**RE: Townhome for Jason Buchanan
1106 Griegos NW
Grading and Drainage Plan
Engineer's Stamp Date: 12/6/18
Hydrology File: F14D058A**

Based on the submittal received on 12/7/18, the Grading and Drainage Plan cannot be approved until the following are corrected:

TOWNHOME FOR JASON BUCHANAN 1106 GRIEGOS RD., NW GRADING AND DRAINAGE PLAN			
DRAWING:	DRAWN BY:	DATE:	SHEET #
201843-GD.DWG	SH-B	12-06-2018	CIVIL 102

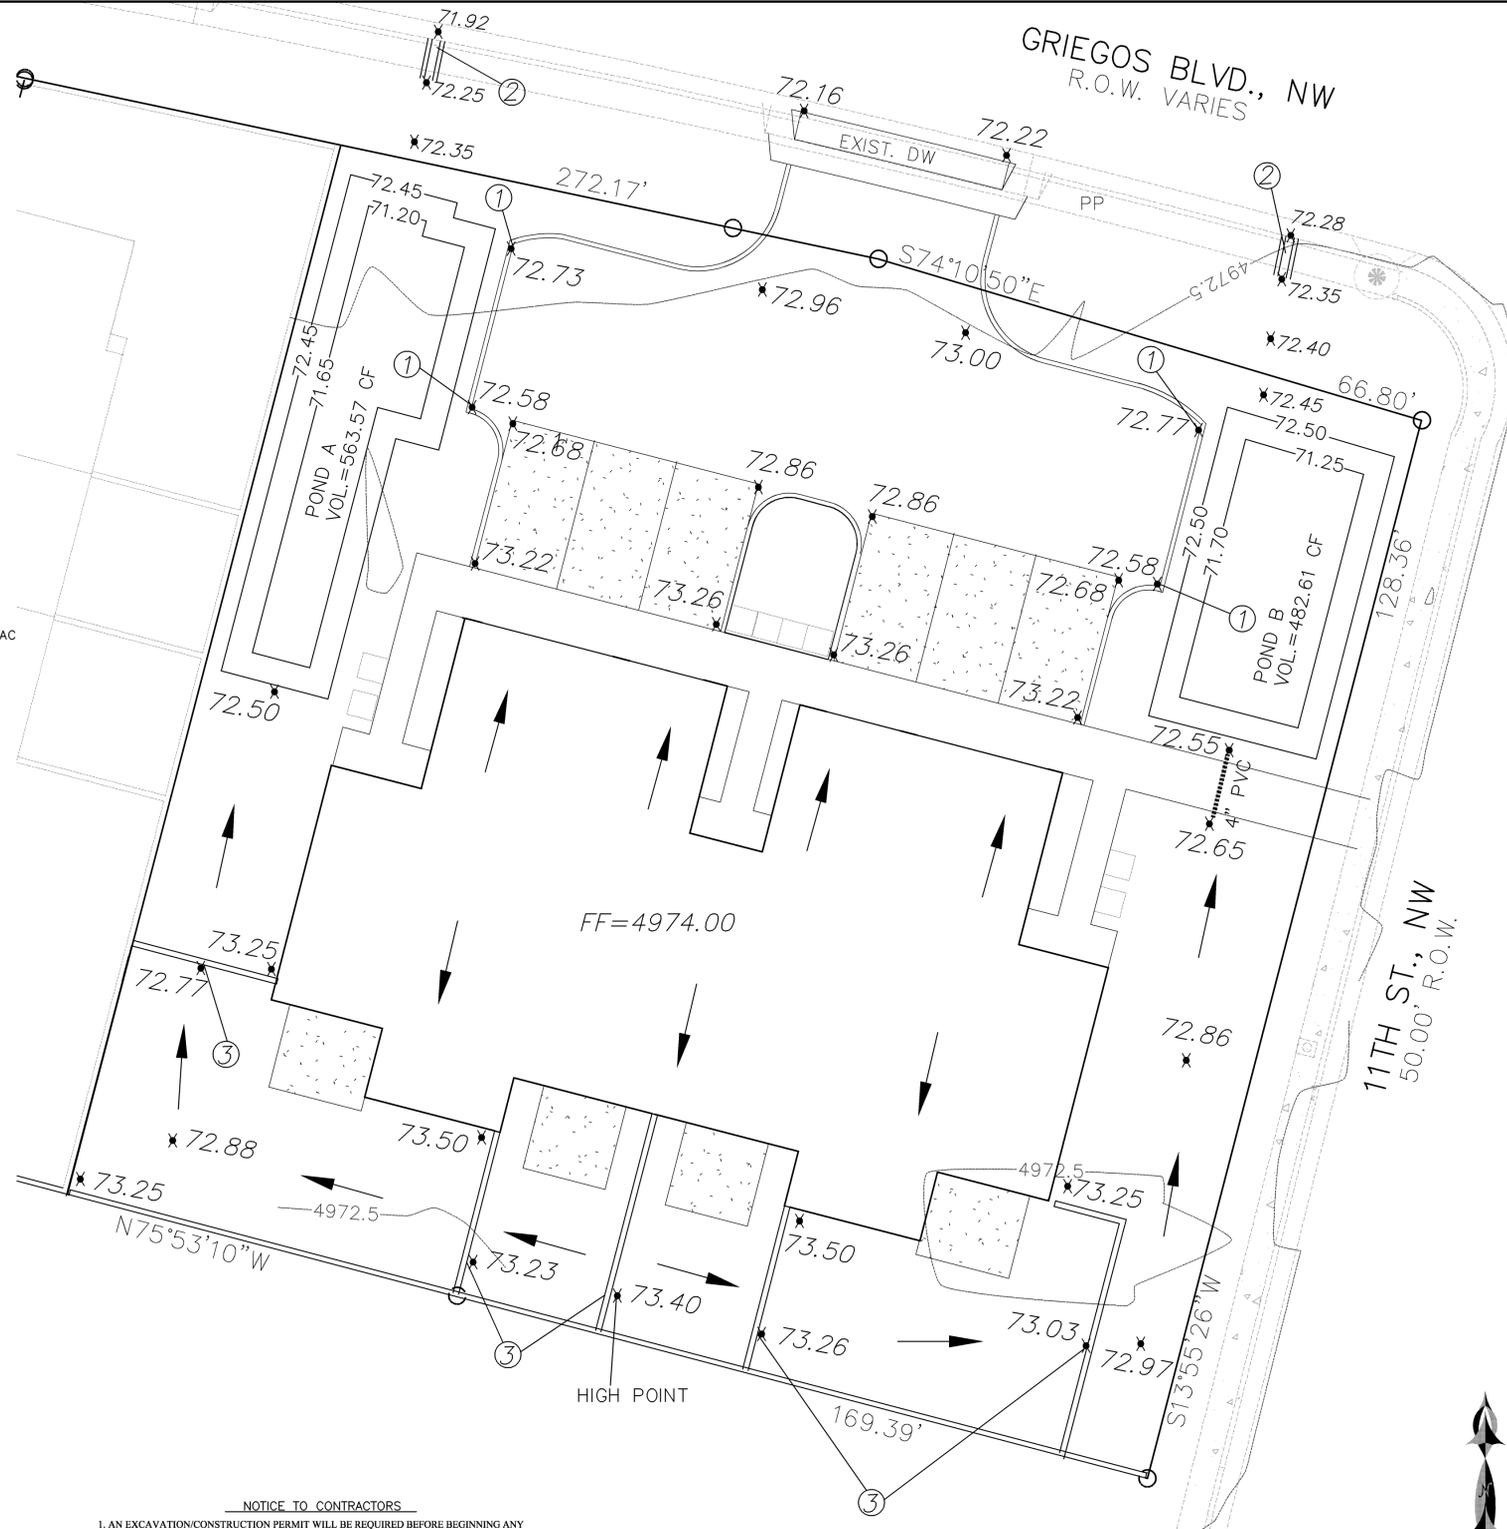
1. The site must demonstrate adequate downstream capacity per § 14-5-2-12(G) of the Albuquerque Code of Ordinances.
2. The unofficial policy of allowing 2.75cfs/acre discharge in the Valley is no longer accepted. Sites must demonstrate downstream capacity or pond the increased runoff onsite. Remove all references to the 2.75cfs/ac allowance. This site does not appear to discharge to the ROW, therefore onsite ponding of the 100-yr, 6hr storm is likely required. Part of the North portion of the site may drain to Griegos, but this needs to be delineated and quantified if attempting to match some historic discharge rate.

3. Under "Calculations" reference is made to the AHYMO input and summary files, but none are provided.
4. The existing survey needs to be supplemented with spot elevation due to the lack of elevation relief here.

5. Include flowline and top of curb elevations along Griegos at the curbcut and sidewalk culverts. Provide a waterblock, 0.87' high, at the entrance. Ensure impervious runoff from the site gets routed into the stormwater ponds and doesn't simply flow out through the entrance.

6. Define existing vs. proposed walls; do not place additional fill against existing walls. The existing wall on the west side of the site has an odd meander; will it remain or be rebuilt?
7. The “Notice to Contractors” notes are duplicated. Also, include the [standard SO-19](#) notes on the grading plan and callout the sidewalk culverts to be constructed by SO-19 permit.
